Office Action Summary

10/708,855

MILLS, CHRISTOPHER J.

DETAILED ACTION

Reproduced from Viking Archived Website (Examiner amended Fig. 1)

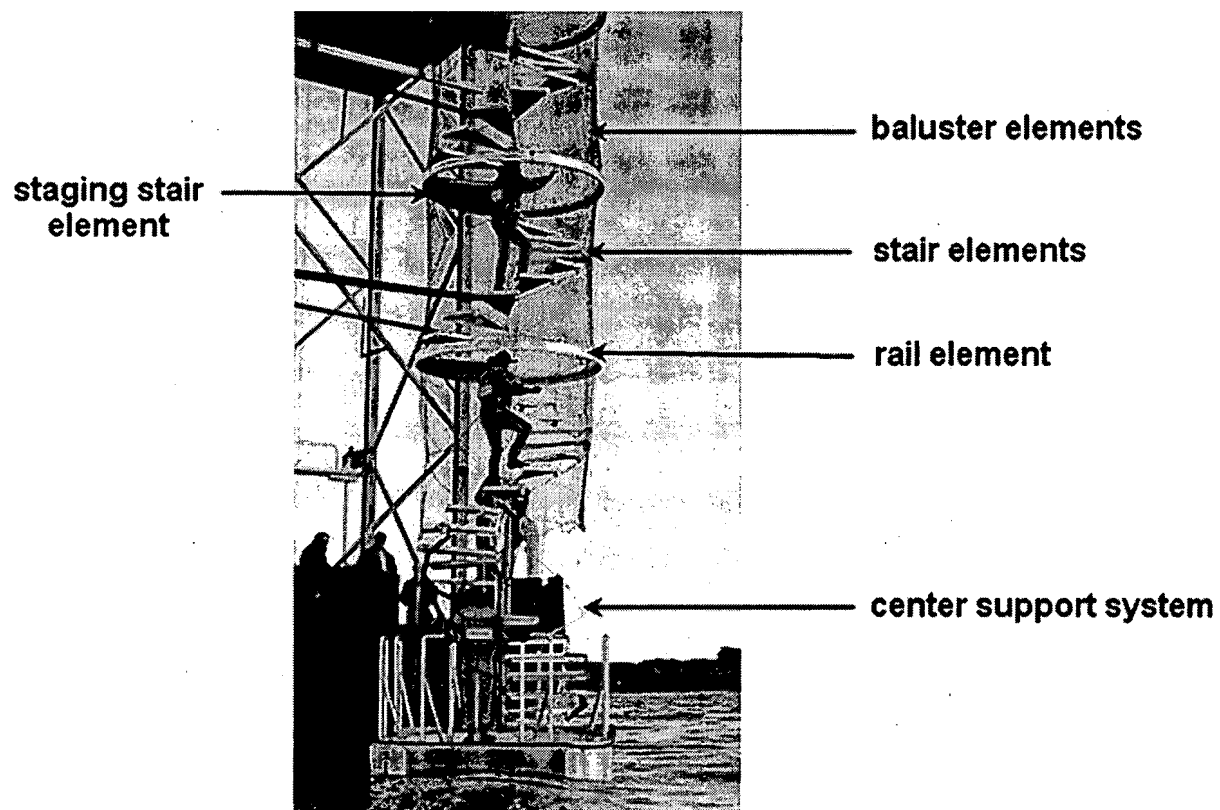
9. Regarding claim 1, Viking discloses a collapsible spiral staircase having all of the applicant's claimed structure, including:

- a. “at least one rail element...” (ring-shaped “rail elements,” examiner amended Fig. 1).
- b. “...a plurality of stair elements...” (“stairs,” examiner amended Fig. 1).

- c. "...a plurality of baluster elements coupled to said at least one rail element and to said plurality of stair elements..." (the vertically-oriented strands of the surrounding netting are "baluster elements," examiner amended Fig. 1).
- d. "...a center support system coupled to and supporting said at least one rail element and said plurality of stair elements, and having a stowed state and a deployed state." ("center support system" refers to plurality of vertical winch wires that extend the length of the staircase, examiner amended Fig. 1).

10. Regarding claims 2 and 13, Viking discloses rail [claim 2] and baluster [claim 13] elements in the form of a potential energy devices ("rail element" and "baluster

elements," examiner amended Fig. 1). These elements have potential energy proportional to their height above ground-level.

11. Regarding claims 3 and 14, Viking discloses rail [claim 3] and baluster [claim 14] elements that assist in contracting the support system into a stowed state ("rail element" and "baluster elements," examiner amended Fig. 1). Both elements cooperate with winch wires to lift the stairs into a stowed state.

12. Regarding claims 4 and 15, Viking discloses rail [claim 4] and baluster [claim 15] elements that assist the support system into a deployed state ("rail element" and "baluster elements," examiner amended Fig. 1). The potential energy discussed above aids in deployment.

13. Regarding claim 6, Viking discloses stair elements with outer edges and radial edges ("stair elements," examiner amended Fig. 1).
14. Regarding claims 7 and 8, Viking discloses stairs whose outer edges form a circle when stowed [claim 7] and whose radial edges are straight [claim 8] ("stair elements," examiner amended Fig. 1).

15. Regarding claims 10-12, Viking discloses a staging stair element [claim 10] in the form of a step [claim 12] at a fixed height for human standing clearance [claim 11] ("staging stair element," examiner amended Fig. 1).

16. Regarding claims 17-19, Viking discloses baluster elements that are in a curved [claim 17], nested [claim 19] arrangement when stowed, and a substantially straight state [claim 18] when deployed ("baluster elements," examiner amended Fig. 1).

17. Regarding claim 20, Viking discloses rail, stair, and baluster elements that form a disc-shaped structure when stowed (examiner amended Fig. 1).
18. Regarding claims 29 and 30, Viking discloses a collapsible spiral staircase system capable of being stowed in a floor [claim 29] or ceiling [claim 30] (examiner amended Fig. 1).

20. Regarding claim 36, Viking discloses a spiral staircase system comprising:
 - a. "...at least one circular rail element..." ("rail element," examiner amended Fig. 1).

- b. "...a plurality of stair elements having circular outer edges..." ("stair elements," examiner amended Fig. 1).
 - c. "...a plurality of baluster elements coupled to said at least one rail element and to said plurality of stair elements..." (the vertically-oriented strands of the surrounding netting are "baluster elements," examiner amended Fig. 1).

- d. "...a center support system coupled to and supporting said at least one rail element and said plurality of stair elements, and having a stowed state and a deployed state." ("center support system" refers to plurality of vertical winch wires that extend the length of the staircase, examiner amended Fig. 1).

21. Regarding claim 37, Viking discloses a spiral staircase system that forms a disc-shaped structure when in a stowed state (examiner amended Fig. 1).

Reproduced from U.S. Patent No. 5,088,248

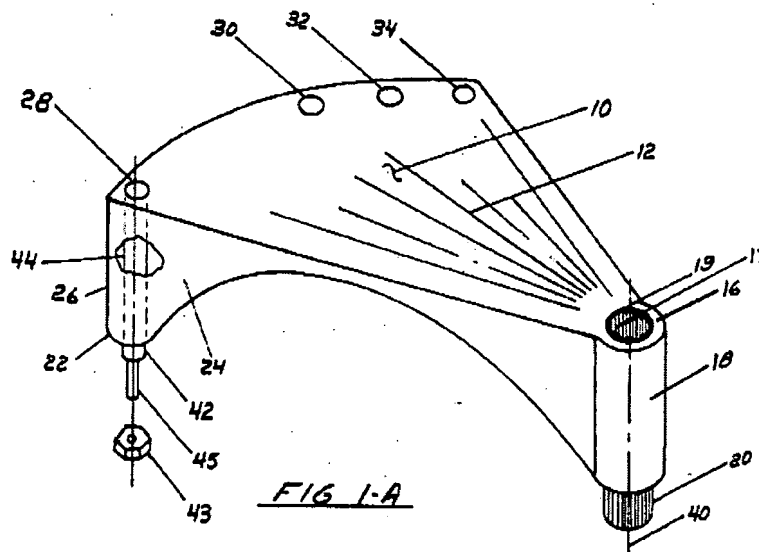
- a. Viking discloses a circular staircase system as set forth above.
- b. Viking does not expressly disclose stairs with curved radial edges.
- c. Manna discloses circular staircase stairs with curved radial edges ("front" 24, Fig. 1A). Adding curves to the radial edges as taught by Manna adds strength to the stair.
- d. The examiner further notes motivation for combining the references as set forth in Manna: "The front 24 of the tread may be shaped for rigidity and strength" (column 3, lines 1-4).
- e. Viking and Manna are analogous art because both are from the field of endeavor of circular staircases.
- f. At the time of the invention, it would have been obvious to a person of ordinary skill in the art to modify the circular staircase of Viking with curved radial edges as taught by Manna, in order to strengthen the stair.

Reproduced from U.S. Patent No. 6,431,103

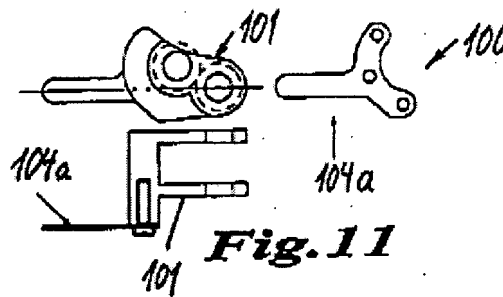
- a. Viking discloses a circular staircase system as set forth above.
- b. Viking does not expressly disclose that the deployment mechanism, or winch, comprises a deployment handled or a release mechanism releasing the support system.
- c. Meyerdierks discloses a winch with a handle ("handle" 104a, Fig. 11) and a release mechanism ("retaining device 34...releases the winding round the winch drum," column 10, lines 34-40). Adding a handle and release

mechanism to the winch of Viking as taught by Meyerdierks allows manual deployment and storage of the collapsible staircase.

- d. Viking and Meyerdierks are analogous art because both are from the field of endeavor of winch systems.
- e. At the time of the invention, it would have been obvious to a person of ordinary skill in the art to modify the winch of Viking by adding a handle and release mechanism as taught by Meyerdierks, in order to regulate deployment and storage of the staircase.

Reproduced from U.S. Patent No. 4,022,404

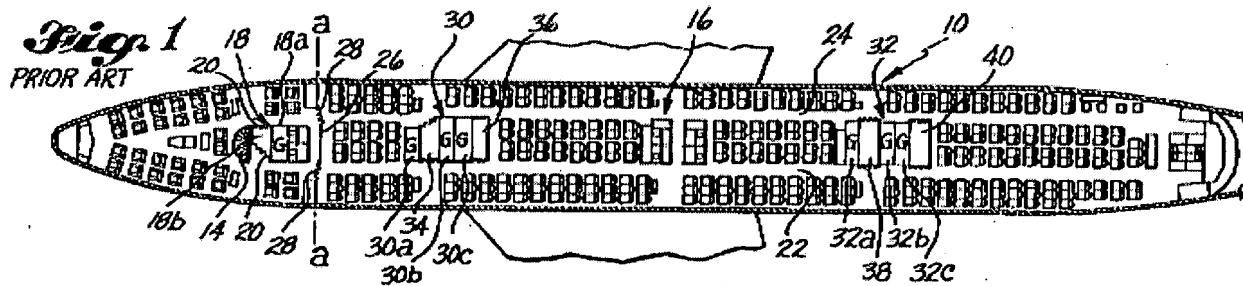
- a. Viking discloses a circular staircase system as set forth above.
- b. Viking does not expressly disclose that the staircase is located in an aircraft.
- c. Greiss discloses an airplane with a spiral staircase ("central spiral stairway" 14, Fig. 1). Putting the collapsible staircase of Viking in an airplane as taught by Greiss would provide access to overhead storage containers without jeopardizing the space used by passengers and crew members.
- d. Viking and Meyerdierks are analogous art because both are from the field of endeavor of spiral staircase placement.
- e. At the time of the invention, it would have been obvious to a person of ordinary skill in the art to modify the staircase of Viking by using it in an

airplane as taught by Greiss, in order to provide access to overhead storage containers without jeopardizing the space used by passengers and crew members.
